ECE/TRANS/WP.29/GRSG/2009/3
3 February 2009

REGULATION No. 110 (Specific components for CNG)

Proposal for draft amendments to the Regulation

"Fig. 2: 20 MPa Filling unit Size 2 (receptacle) for M₂, M₃, N₂ and N₃ vehicles

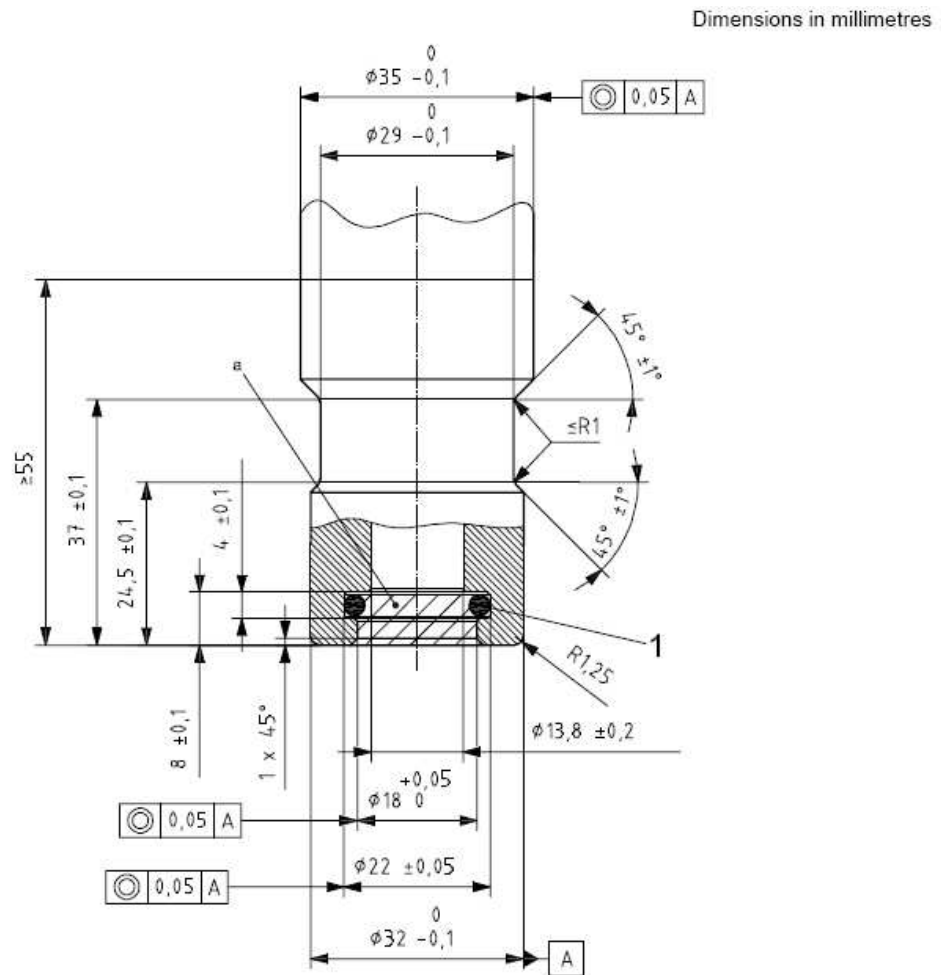
Insert a new paragraph 4.2., to read:

"4.2. Figure 2 shows the dimensions of the filling unit for vehicles of categories M₂, M₃, N₂ and N₃. 3/"

Insert a new Figure 2, to read:

1 sealing ID = $\phi 15,47 \pm 0,1$ width = $3,53 \pm 0,2$

^a This area shall be kept free of all components

Surface roughness < Ra 3,2 μm .

Sealing surface finish: 0,8 μm to 0,05 μm .

Material hardness: 75 Rockwell B (HRB 75) minimum.
